Technical Note TN-769

Channel Audio Switch Modifications for the T1550 LTU, T1511 CCM and T1711 CMM

16 May 2003

Figure 1: T1550 LTU PCB modification completed

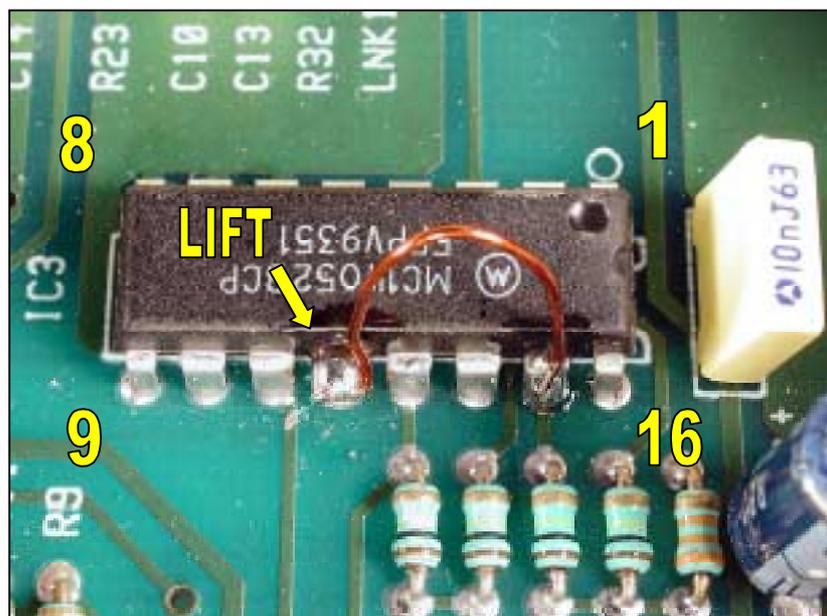
1. Lift IC3 pin 12.

2. Join pins 12 and 15 of IC3 with the enamel coated wire.

Figure 2: T1511 CCM PCB modification completed

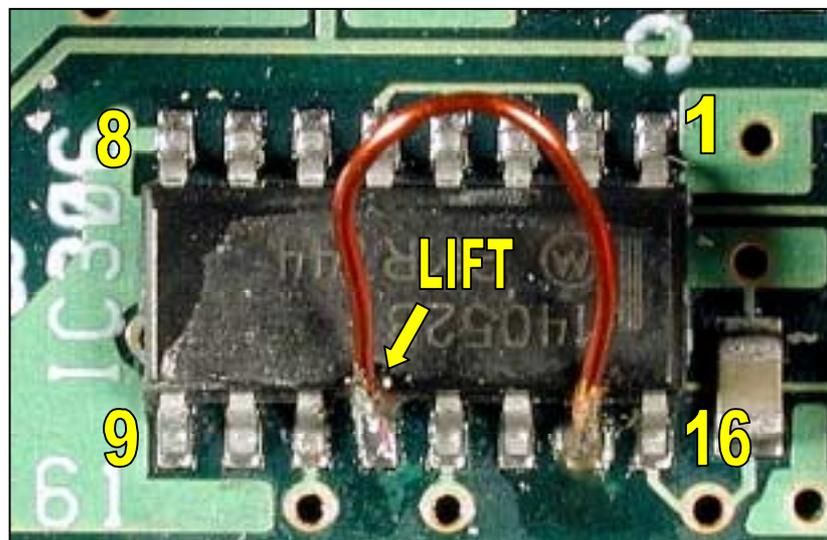
1. Lift IC306 pin 12.
2. Join pins 13 and 15 of IC306 with the enamel coated wire.

Figure 3: T1711 CMM resistor modifications completed

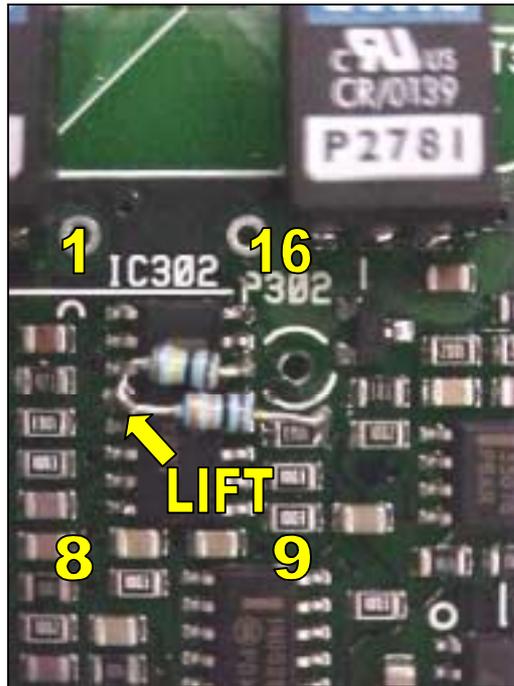
1. Lift IC302 pin 4.

2. Solder the 100K resistor from IC302 pin 14 to IC302 pin 4 (the pin that was lifted in step1).

3. Solder the 10K resistor from IC302 pin 4 to R327 mid rail point. (End furthest away from IC302). See Figure 3 below for an illustration of the finished modification.

Figure 4: T1711 CMM wire modifications completed

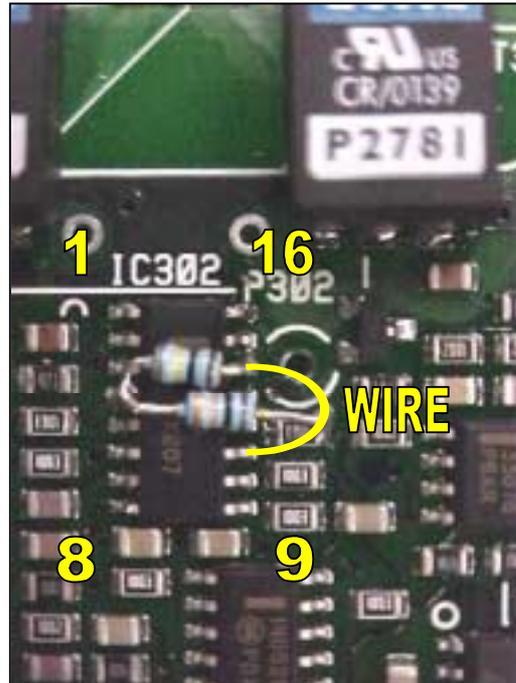
5. Join pins 11 and 14 of IC302 with the enamel coated wire (see Figure 4 below).
